Special Bryant Planning Commission Meeting

Date: March 24, 2025 - **Time:** 6:00 PM

1. Hawkins Valley Phase 1 - Preliminary Plat

GNE response to comments drawn in red

PRE DEVELOPED BASIN
 C=0.47
 I=5.60 IN/HR
 A=44.03 ACRES
 Q₁₀₀=115.89 CFS

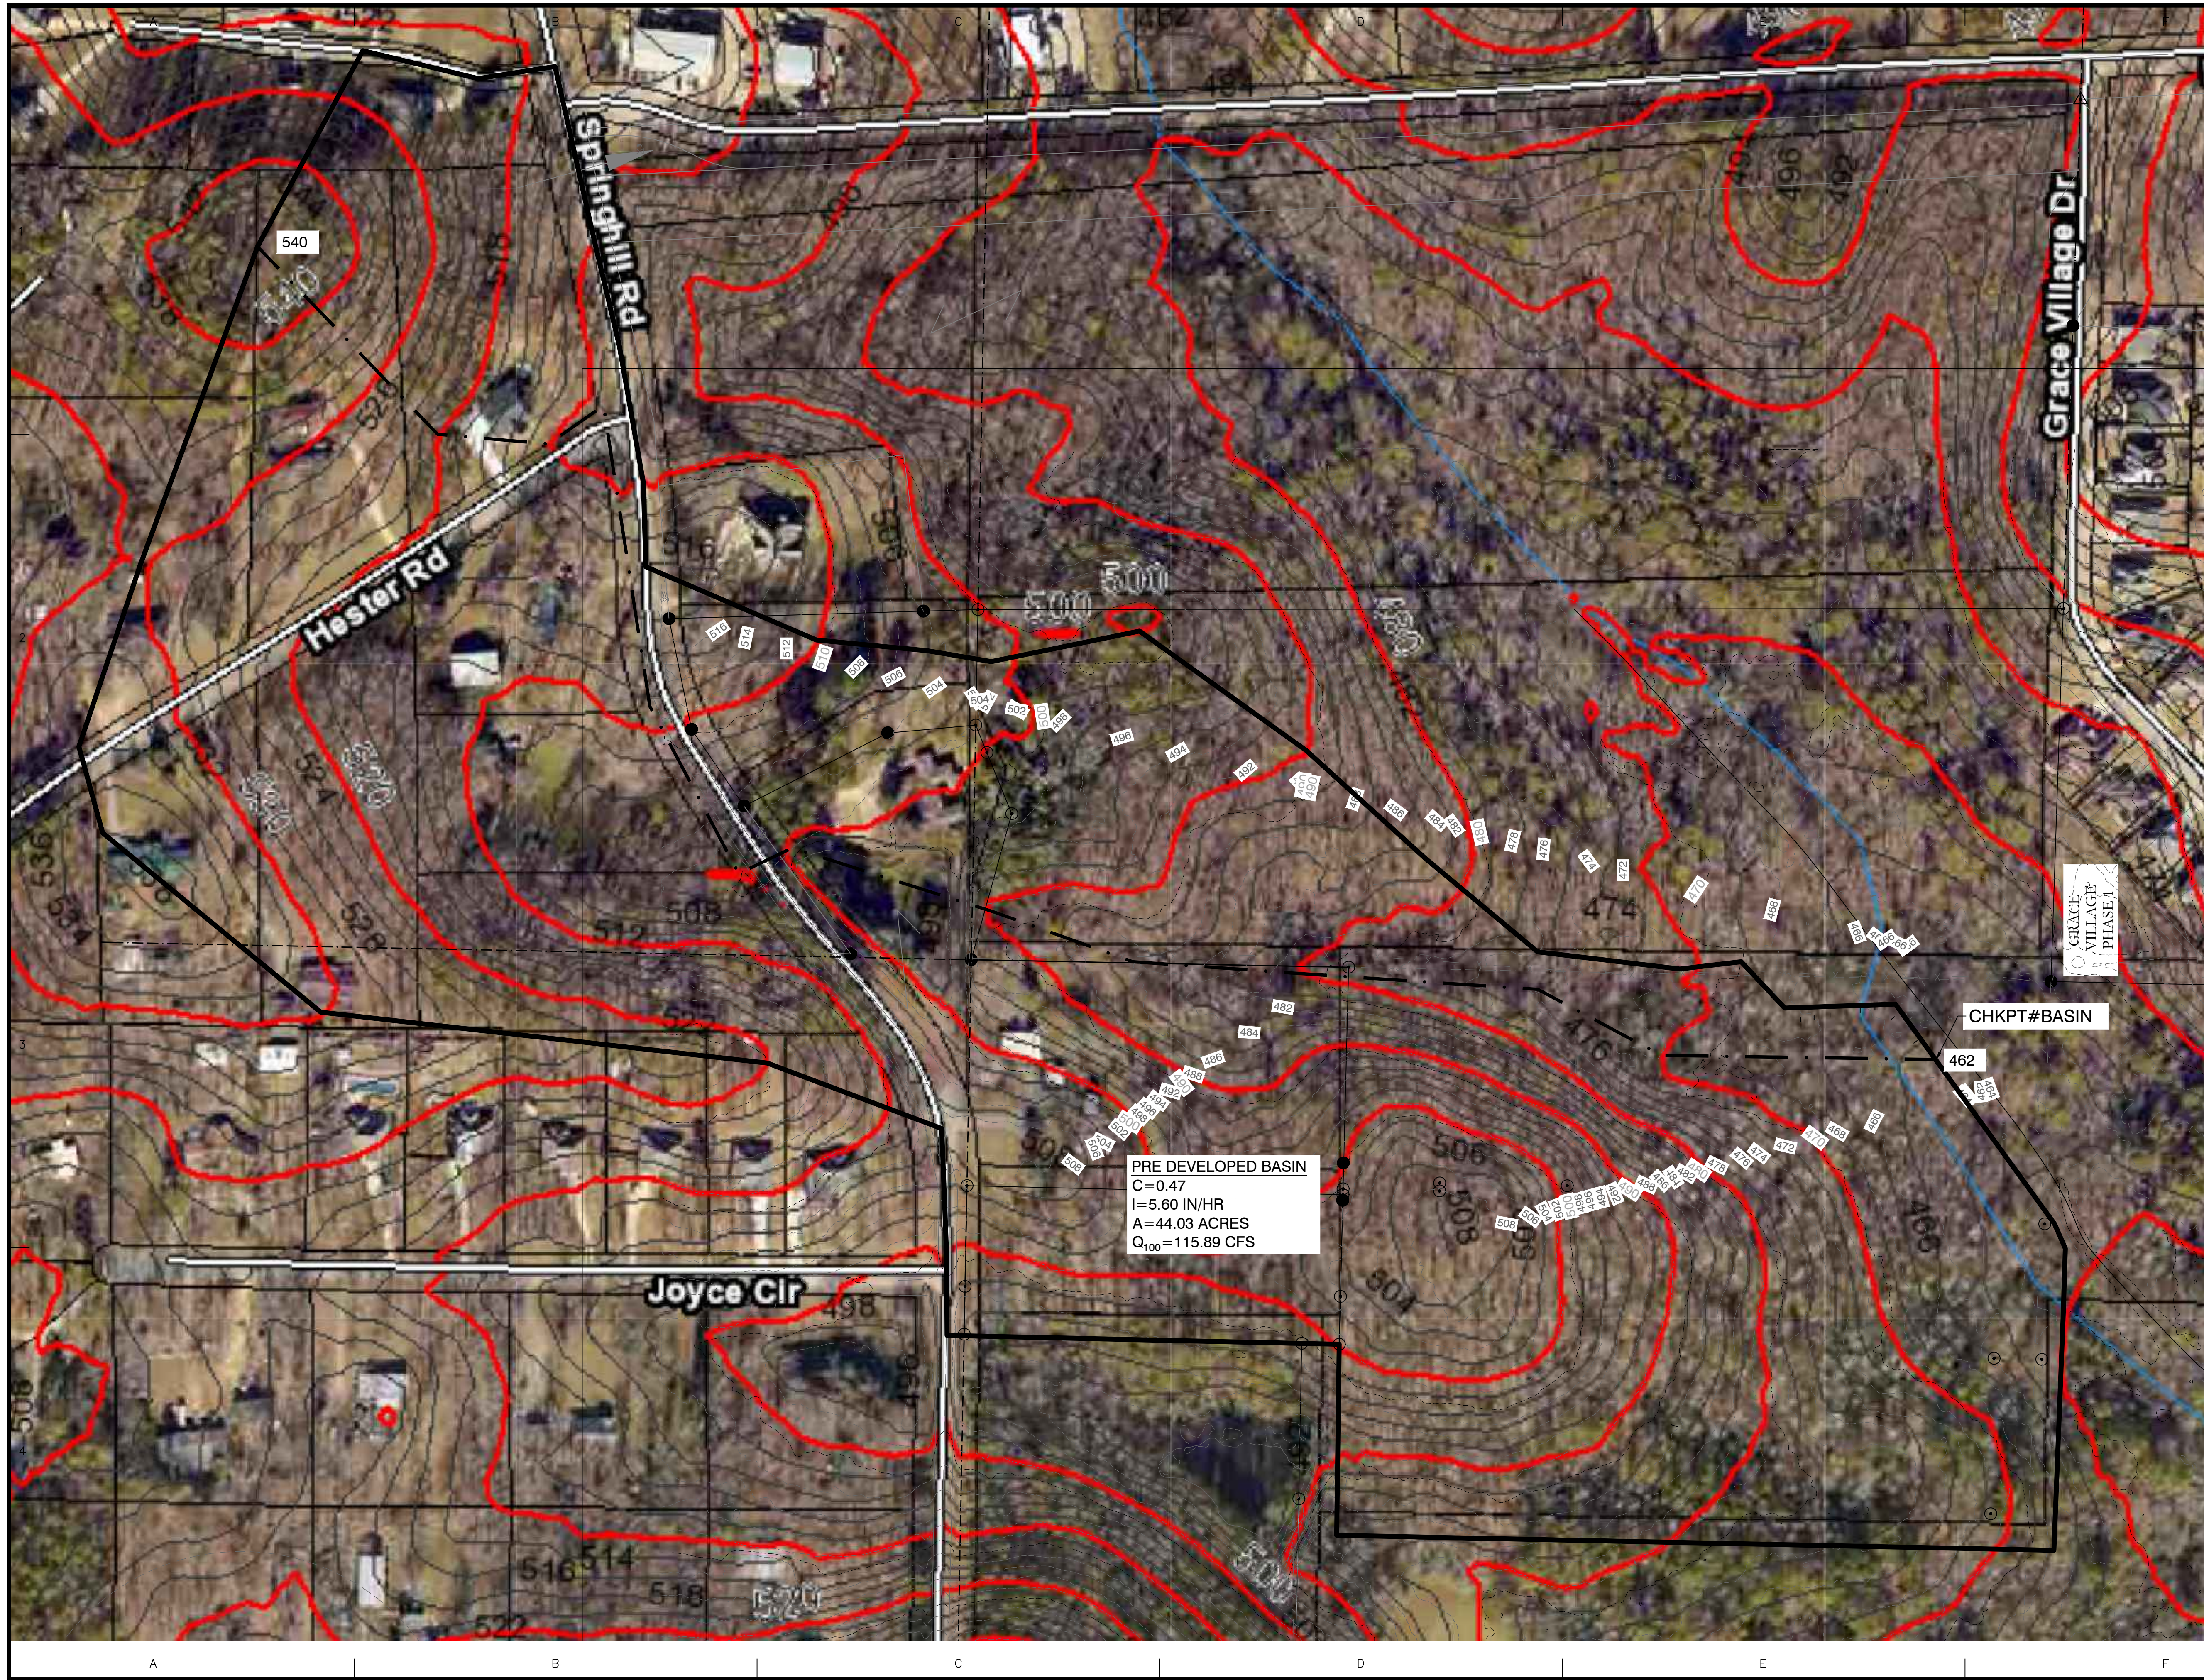
1. Page 3 – justification for roughness coefficients REFERENCE ADDED.
2. Page 4 – duplicate? NO, IT IS FOR POST DEVELOPMENT. IT WAS DESIGNED PER POST DEVELOPMENT FLOW. SEE PAGE 24 & 25

3. Page 9 – what basins is this based upon – see smaller basins / comments on page 22
4. Pages 11 & 12 – verify drainage basins SEE BELOW***
5. Page 13 – see comments on plan sheet PIPE SLOPES, SIZES, DITCH DETAILS, AND WEIR DETAILS ADDED. SEE PAGE 26 & 27.

6. Page 21 – Show enclosed storm pipe calculations for inside proposed phase PIPE SIZE CALCULATED BASED ON INLET BASIN.
7. Page 21 – Show ditch sizing calculations based upon actual contributing basins DITCH IS SIZED PER CONTRIBUTING BASIN.

8. Page 22 – see other basins not included in the calculations.
 - a. Show pond details and layout including control structure POND DETAILS AND WEIR DETAILS ADDED SEE PAGE 26 & 27.

- b. Show pipe sizes, slopes etc PIPE SLOPES, SIZES ADDED. SEE PAGE 26
 - c. Label ditch, show details,, slope, lengths, DITCH DETAILS, SLOPE AND LENGHT ADDED AND LABELLED. SEE PAGE 26 & 27.

9. Page 33 - Somewhere show a summary of the results of the pond and weir calculations ADDED PAGE 2.
10. Page 39 – Show details on pond POND DIMENSION, DEPTH AND WEIR DETAILS ADDED. SEE PAGE 26 & 27.

*** WE AGREE WITH THE BASINS. HOWEVER, WE DIDN'T CHANGE THE BASIN TO MEET THE BRYANT DEADLINE. WE WOULD LIKE TO ADD OUR PROJECT TO THE FEBRUARY AGENDA. ALL FLOWS ARE RELEASED TO THE CREEK TO COMPLY WITH THE BRYANT DRAINAGE CODE.
